**From:** [Alison Kennedy](#)  
**To:** [Hayley Smith](#)  
**Cc:** [Abigail Murphy](#)  
**Subject:** RE: South West Rugby Design Code  
**Date:** 27 May 2025 12:31:01  
**Attachments:** [image001.png](#)  
[image002.png](#)  
[image003.png](#)  
[image004.png](#)  
[image005.png](#)  
[image006.png](#)

**The Town and Country Planning (Local Planning) (England) Regulations 2012  
South West Rugby Design Code Supplementary Planning Document public  
consultation**

Catesby Estates' Consultation Response Table to the South West Rugby Design Code SPD (February 2025)

Illustrative Mark-Up of Draft Framework Masterplan on Page 22 of the Draft for Consultation (10 February 2025) of the South West Rugby Design Code Supplementary Planning Document

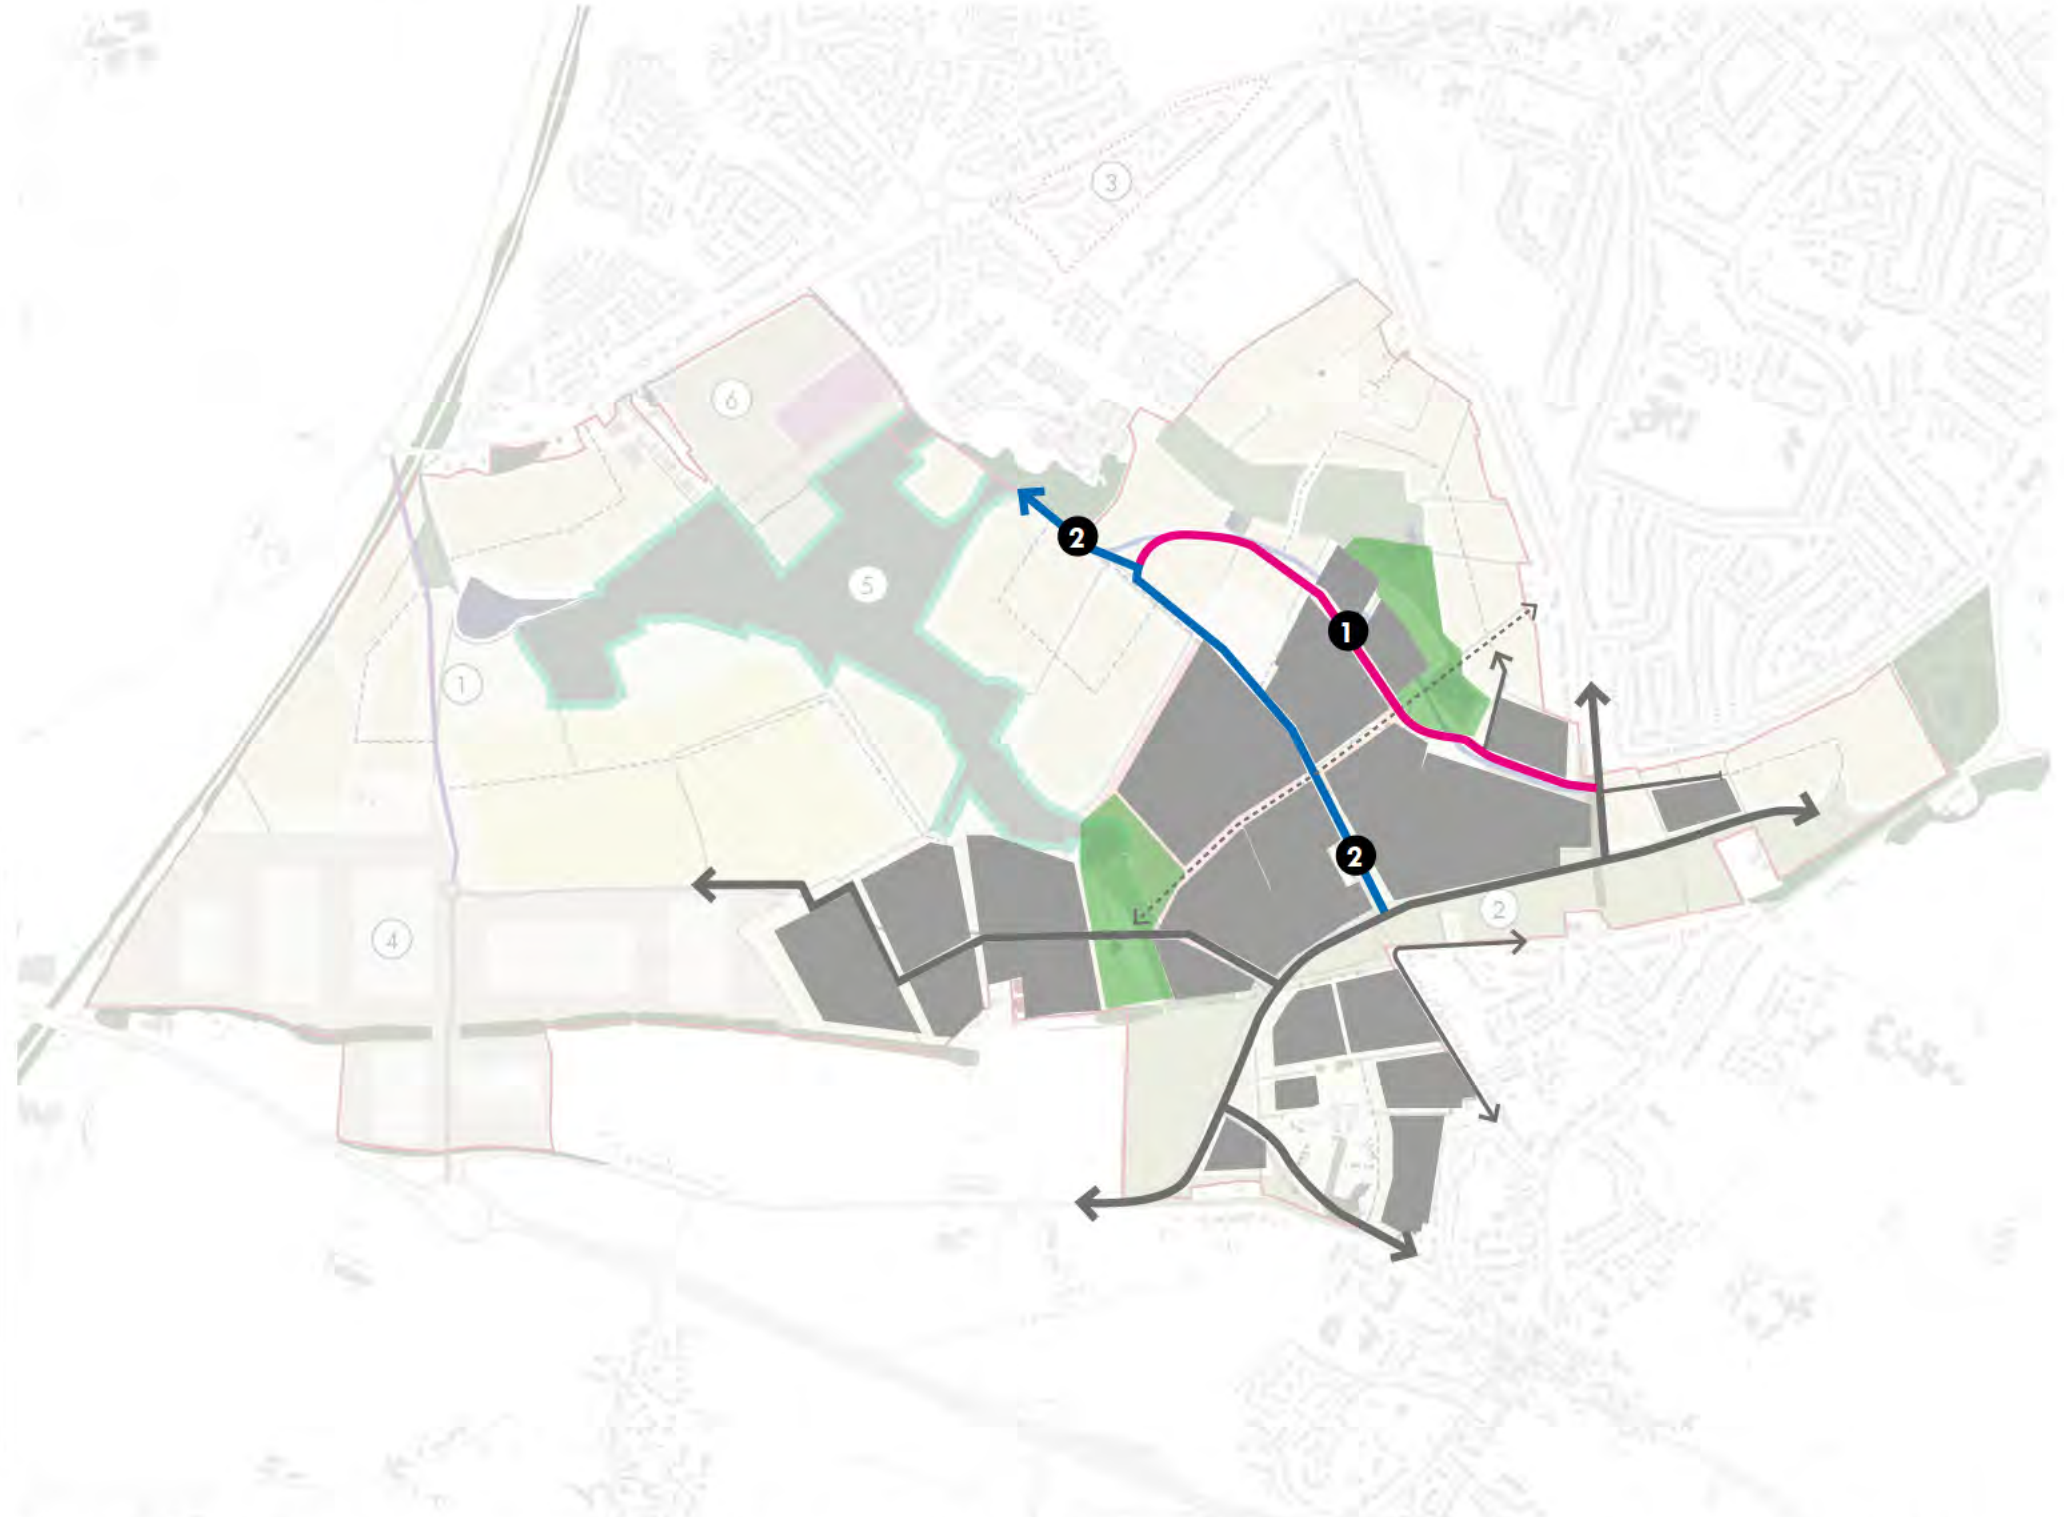
- 1** **Alignment of Community Spine Road (Dunkleys Street) does not align with Homes England's Submitted Planning Application (R24/0733) throughout the Code.** Suggest the Framework Masterplan and its associated diagrams are updated to align with the submitted application.
- 2** **Alignment of Cawston Lane does not align with Homes England's Submitted Planning Application (R24/0733) throughout the Code.** Suggest the Framework Masterplan and its associated diagrams are updated to align with the submitted application. This should include indicating Cawston Lane as a main route.

As the Community Spine Road and Cawston Lane have been submitted as a detailed application, suggest it is made clear these will not be subject to this Design Code and these form a part of the baseline conditions the code is being developed upon.

# Suggested Updates to the Mixed Use Centre Area

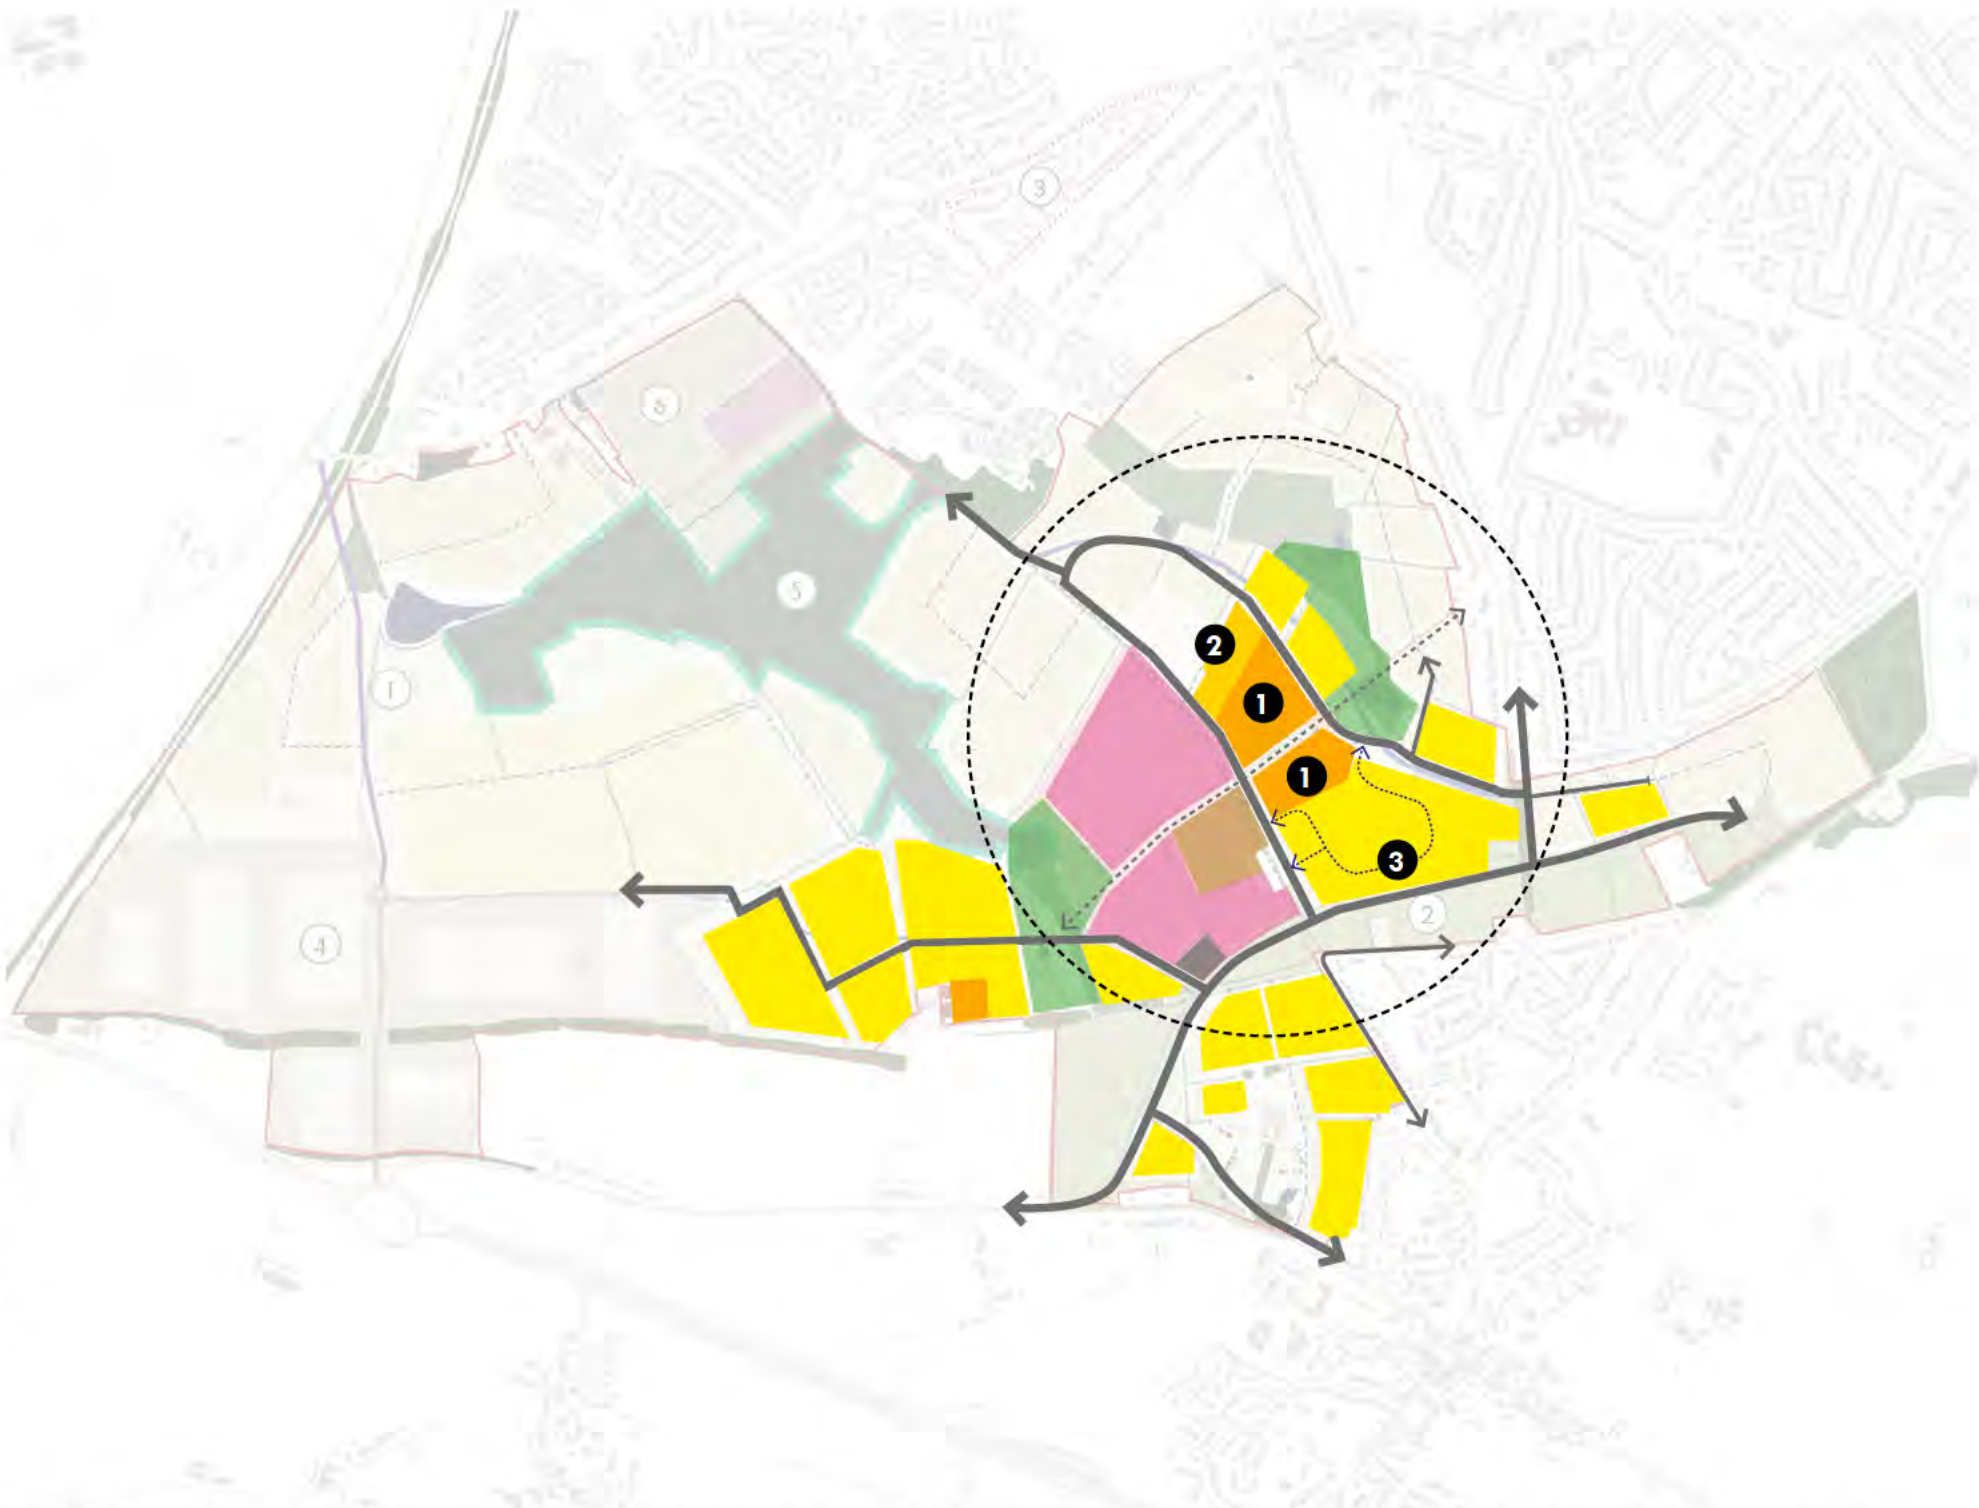
**1** Suggested amendment to the extent of the Mixed Use Centre

We note the plans within the Code are not consistent. We believe the Mixed Use Centre should form a cohesive zone between Cawston Lane and the Community Spine Road (Dunkleys Street) to align with Homes England’s proposals and supported by the Design Review Panel. The proposed extent of the centre should be expanded to the south on the Framework Plan. Please refer to our Draft Land Use Parameter Plan at the end of this document as a reference.

# Suggested Updates to the Edges of Bilton Open Space

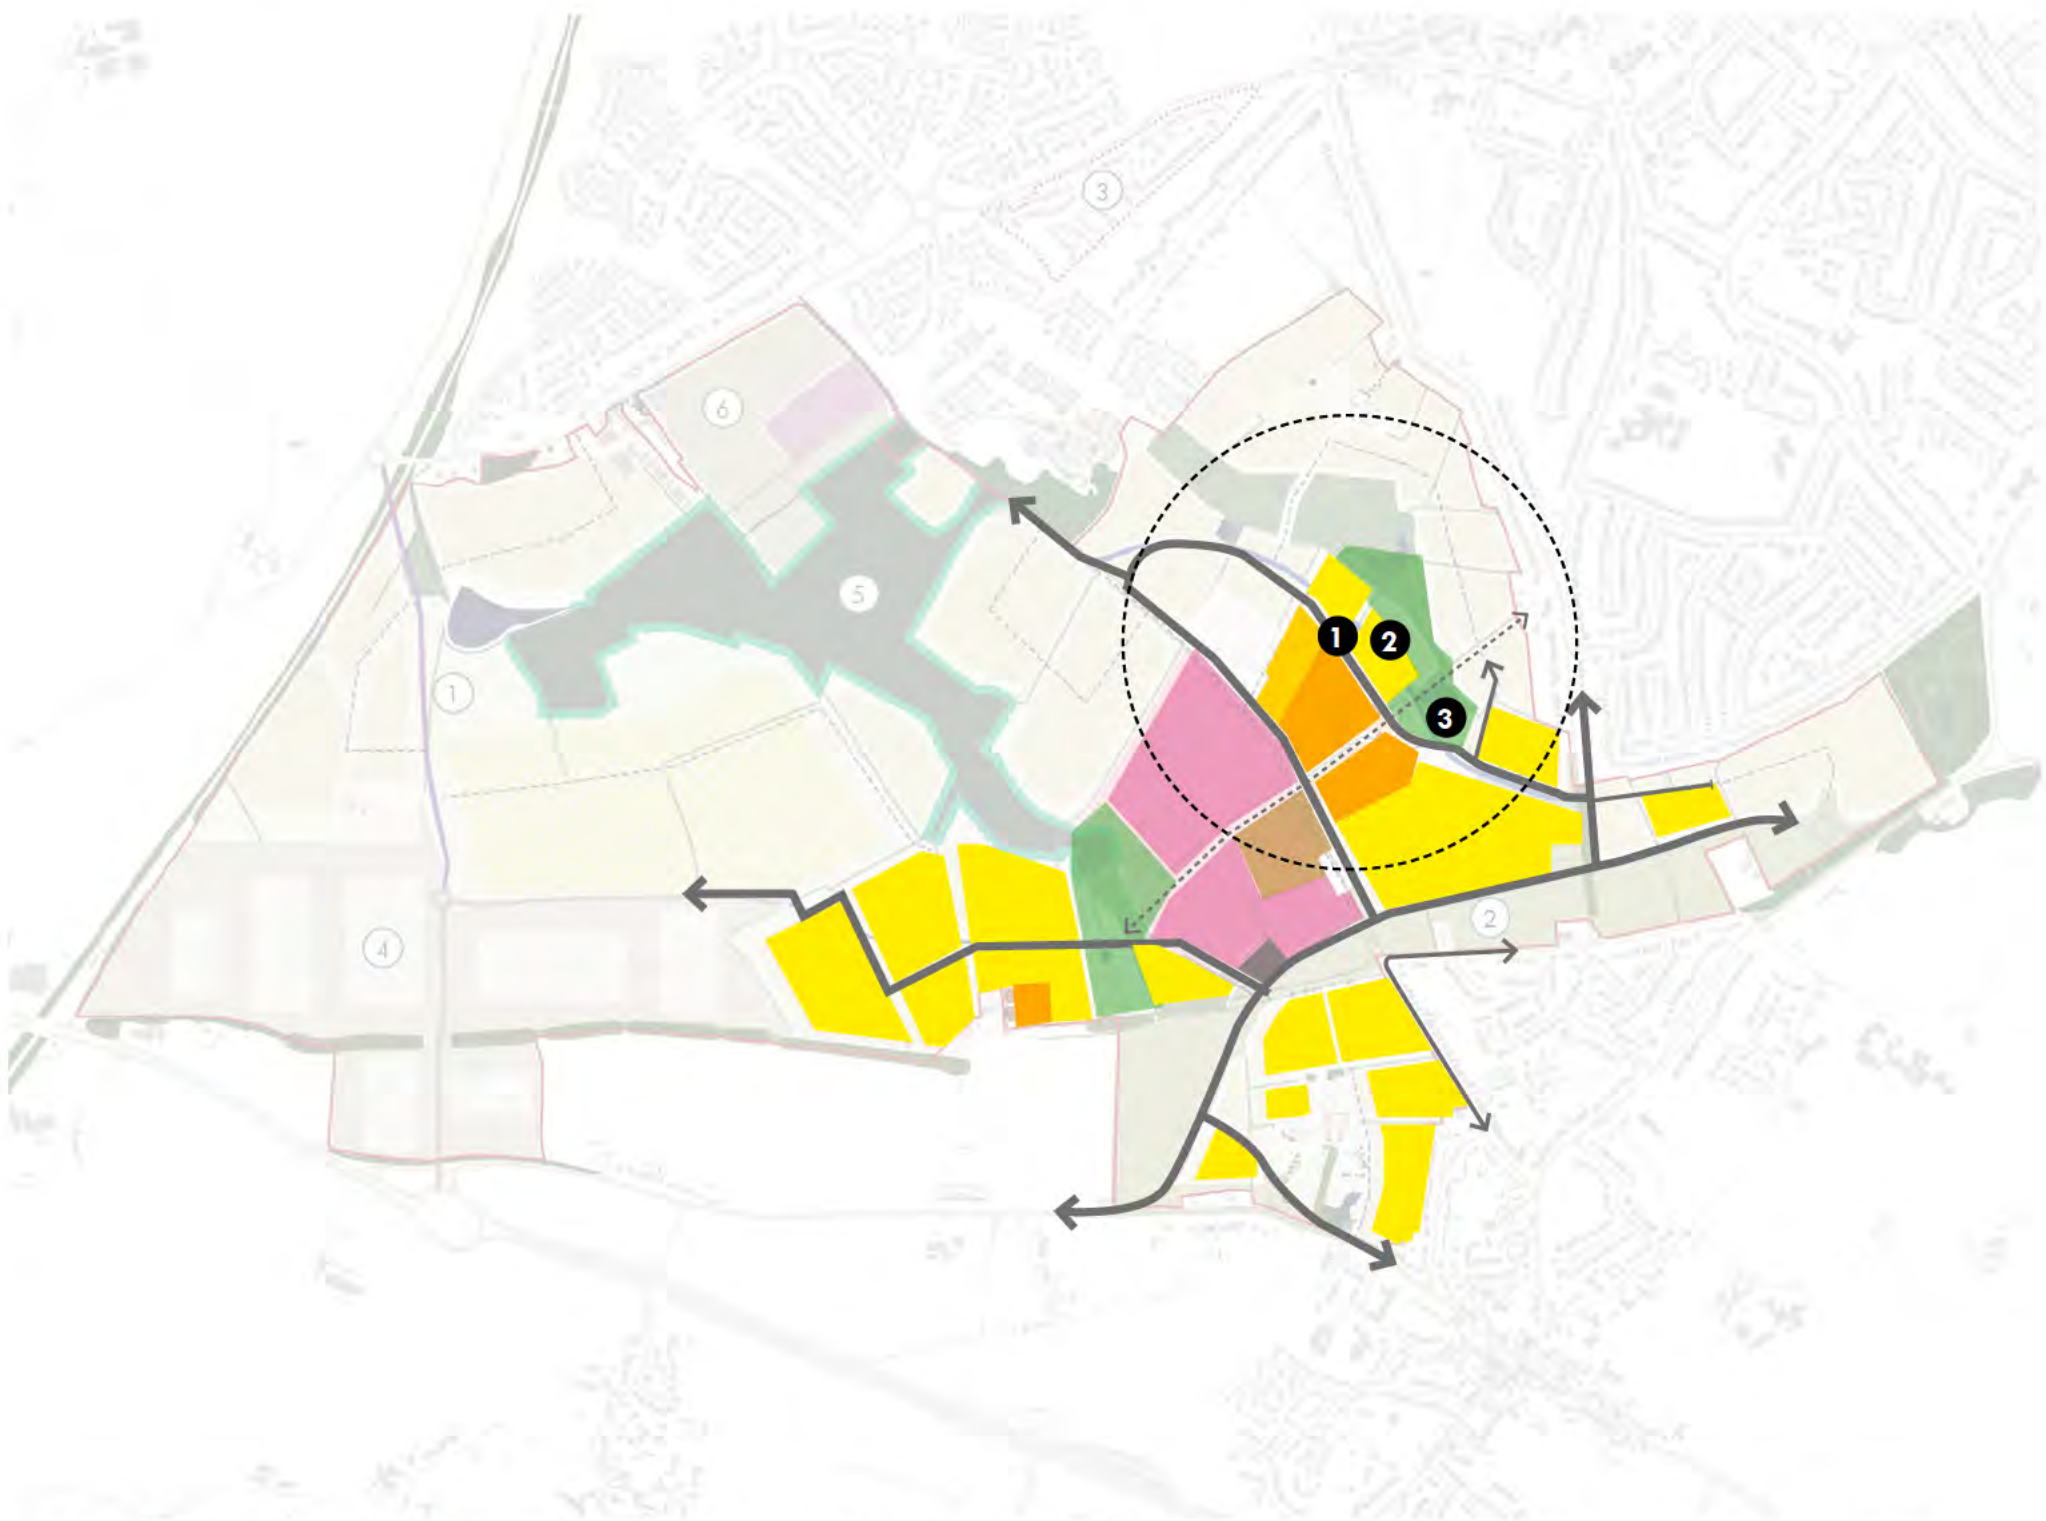
- 1 Alignment of Community Spine Road (Dunkleys Street) should be updated as previously noted on page 46.
- 2 Amendment should be made to the development parcels adjacent to the Community Spine Road to bring them into better alignment with Homes England Land Use Parameter Plan.
- 3 Suggest adjusting Bilton Open Space in this location to better align it with the Community Spine Road's alignment. See submitted planning application (R24/0733) and Draft Land Use Parameter Plan at the end of this document for further reference.
